Red Line Revisions to NCDH Approved Drawings

MODIFICATIONS TO
AQUA NEW YORK, INC.
WATER TREATMENT FACILITY
SEAMANS NECK ROAD
NASSAU COUNTY, NEW YORK

MISCELLANEOUS POWER DISTRIBUTION PANEL MP/LDP-1 RISER DIAGRAM (CRITICAL)

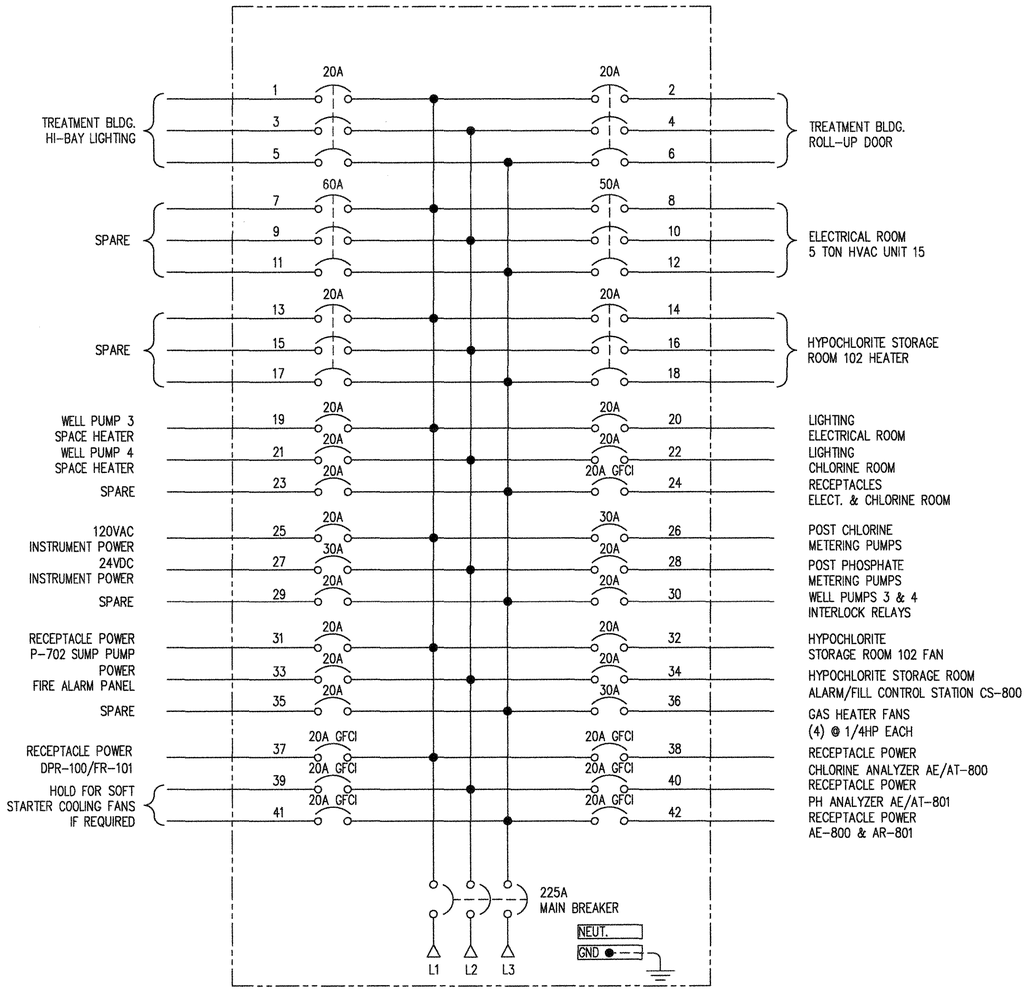
Circuit numbers changed, refer to Schneider Electric Drawing # 031909132-007-01.

POST CHLORINE METERING PUMPS P800A/B

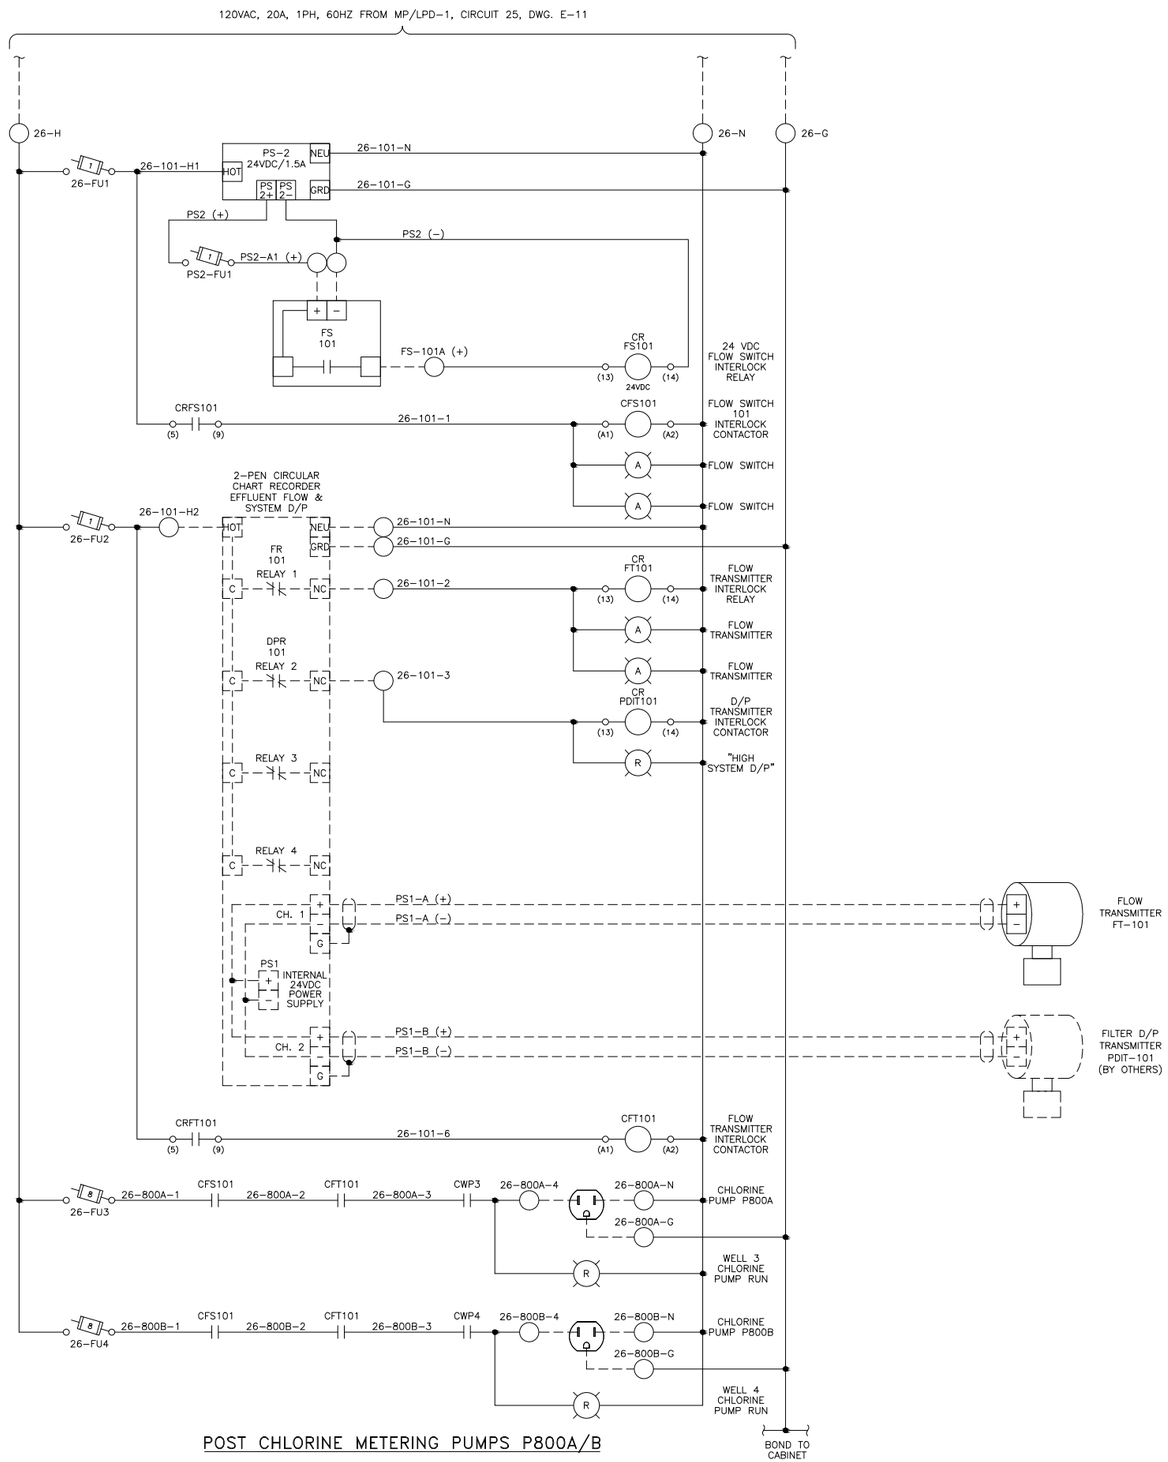
This drawing (D7245-04) represents the latest as-built markup and replaces electrical drawing E-17.

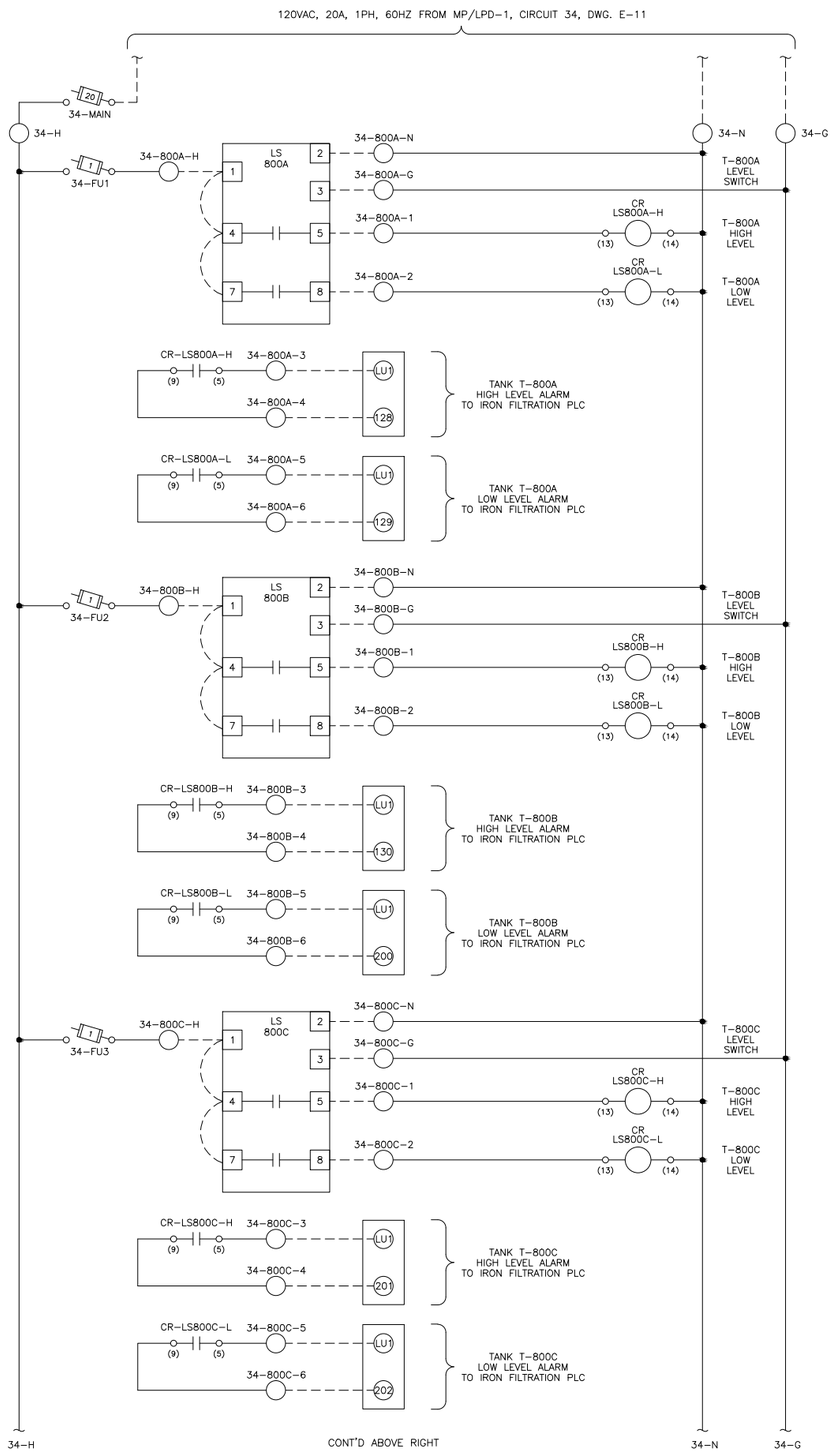
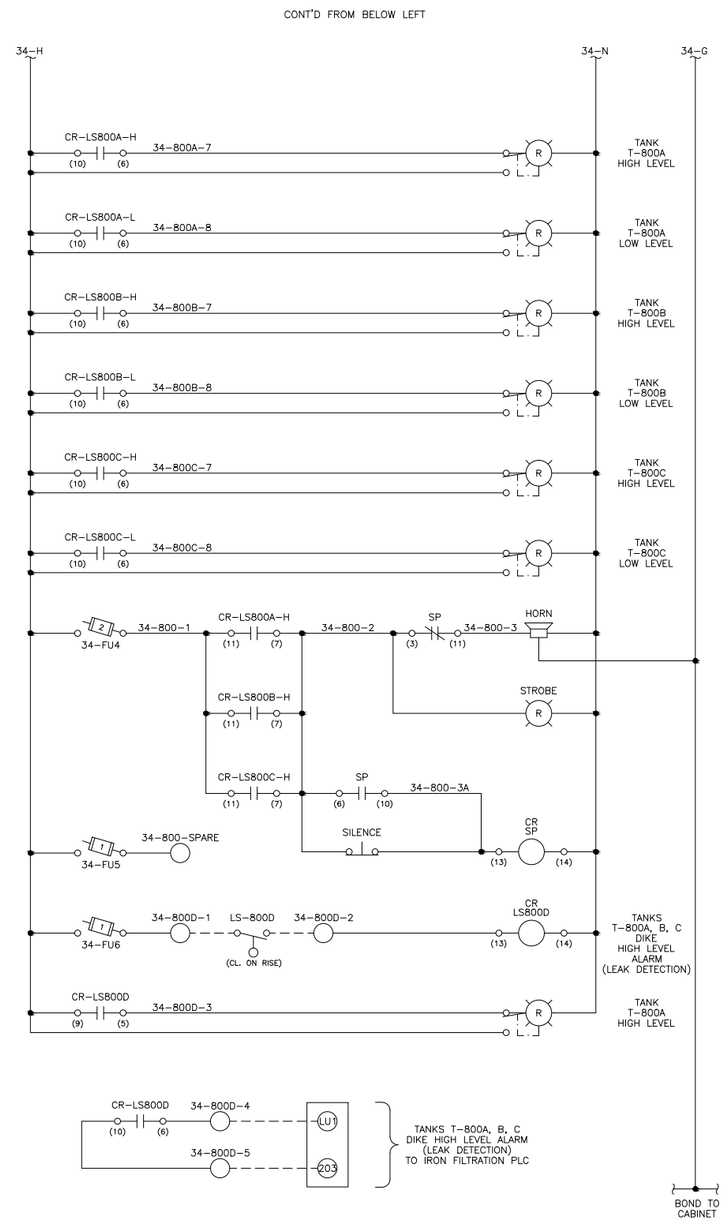
This drawing (D7245-06) represents the latest as-built markup and replaces electrical drawing E-20.
